**CITY OF SNELLVILLE
DEPARTMENT OF PLANNING & DEVELOPMENT
MAYOR AND COUNCIL**

CASE SUMMARY

CASE NUMBER: RZ 19-01 SUP 19-01

DEVELOPMENT/PROJECT: 88-Unit Senior (55+) Apartment Development

The proposed site plan, submitted by the applicant.

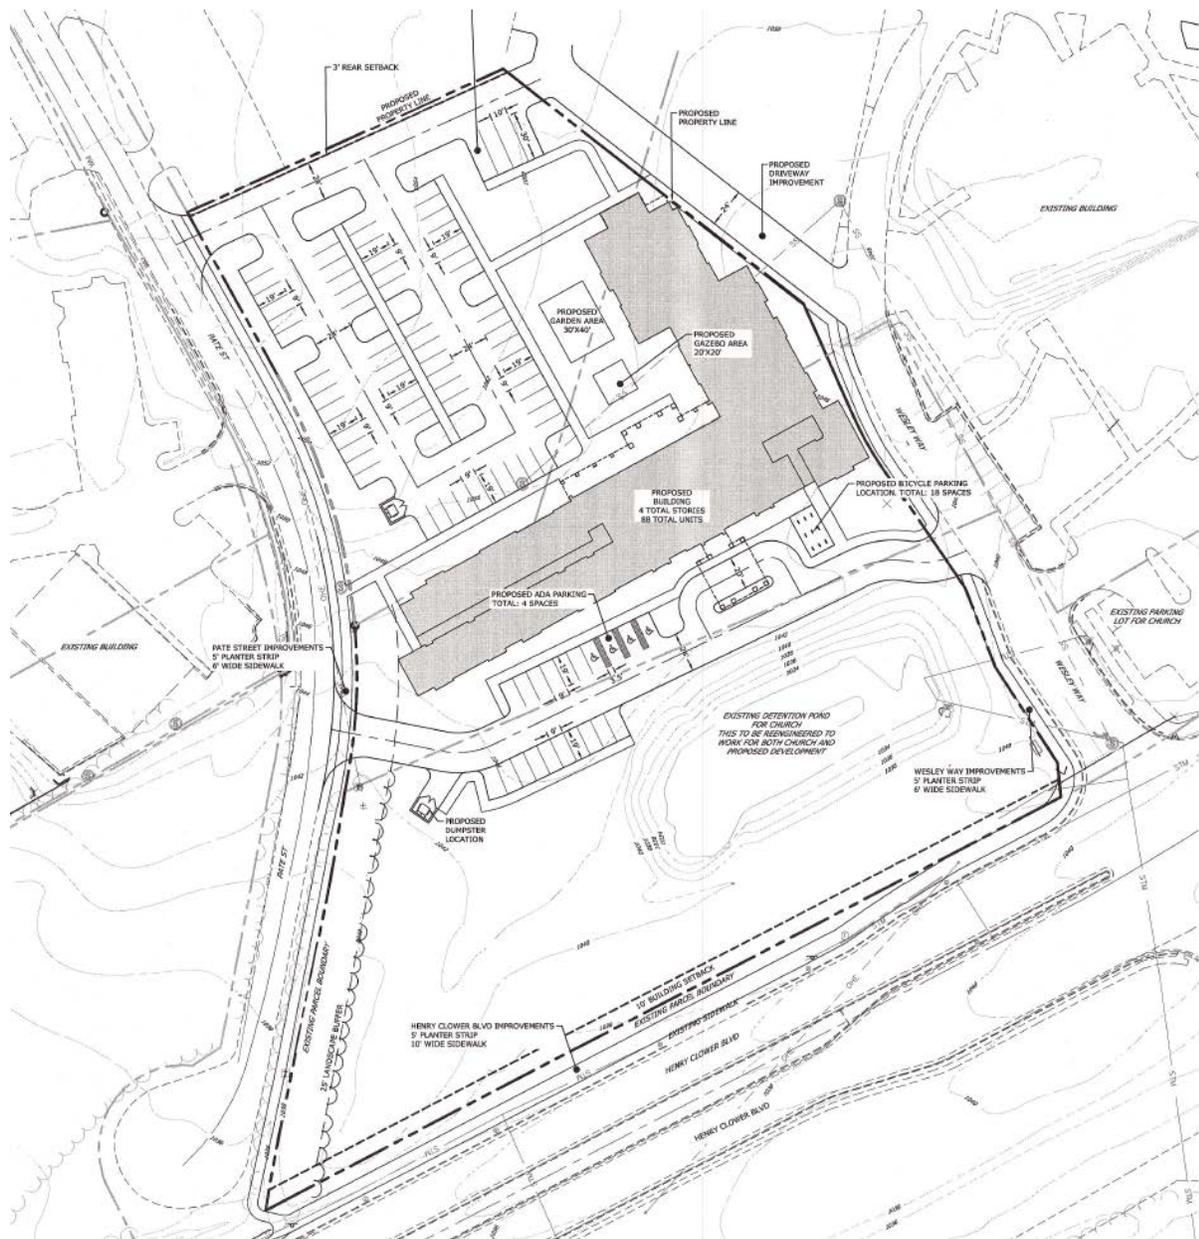
The rezoning site plan entitled “Conceptual Site Plan Layout United Methodist Church Wendover Group”, sealed and dated 3-7-2019 shows the ±4.44 acre site layout of the 4-story senior apartment building, parking and loading locations, amenity area, dumpster locations, ingress/egress drives, existing stormwater detention pond, and location of Henry Clower Blvd. (a County R/W), Pate Street (a City R/W), and Wesley Way (a SUMC driveway).

The 4-story, 111,412³ sq. ft. “L” shaped building is centered midway on the site, with the main entrance on the south elevation of the building facing Henry Clower Blvd. with full-access drives from Pate Street and Wesley Way. The span of the façade of the south elevation is approximately 310 feet in length, requiring variance approval to exceed the 200-foot maximum façade length in the Towne Center zoning districts. The northeastern building wing, measuring approximately 210 feet in total length, abuts the Wesley Way driveway with a 0-5 feet setback from the five (5) foot planter zone and six (6) foot sidewalk.

Primary parking for the senior apartment development is located to the north behind the building and contains four (4) loading spaces, measuring ten (10) feet wide by thirty (30) feet deep and sixty-eight (68) parking spaces, measuring nine (9) feet wide by nineteen (19) feet deep. A secondary parking area is located between the detention pond and front of the main building wing and contains four (4) ADA handicap spaces and sixteen (16) parking spaces, measuring nine (9) feet wide by nineteen (19) feet deep. A bicycle parking pad is located just right of the main entrance designed to accommodate eighteen (18) bicycles. In total, the applicant is providing eighty-eight (88) parking spaces, equivalent to one space per unit.

There is a 10,938 sq. ft. amenity area located behind the building containing a 20’x20’ gazebo area and 30’x40’ garden area. Sidewalk connectivity exists internally and around the perimeter of the site except at the northern end of the site near the two full-access drives at Pate Street and Wesley Way. As required by the code, a ten (10) foot wide sidewalk and five (5) foot

Two solid-waste dumpsters and enclosures are located on the site. The first is located approximately seventy-five (75) feet from the front of the southeast corner of the main building and approximately forty-five (45) feet from the Pate Street R/W. A second dumpster is located behind the main building in the parking area, approximately forty (40) feet from the back of the building and thirty (30) feet from the Pate Street R/W.

There is a twenty-five (25) foot landscape buffer shown on the site plan that extends from the southwest corner of the property and extends north along Pate Street approximately three-hundred-forty (340) feet.

There is an existing stormwater detention dry pond located in the southeast corner of the site that currently serves the SUMC campus. It will be reengineered to accommodate both the SUMC campus and senior apartment site.

Although not shown on the conceptual site plan layout, the development shall be required to meet the Landscaping and Screening requirements of Sec. 9.23(T) of the Zoning Ordinance, as well as the Buffer, Landscape and Tree Ordinance of Chapter 19 of the City Code, as applicable.

1. The property shall be developed according to the proposed site plan entitled "Conceptual Site Plan Layout United Methodist Church Wendover Group", sealed and dated 3-7-2019 with modifications permitted due to engineering restraints, ingress and egress, and/or to meet conditions of zoning or State, County, and City regulations;

4. Continuation of a six (6) foot wide sidewalk shall be required along the property line to the north, between the Pate Street and Wesley Way ingress/egress drives;
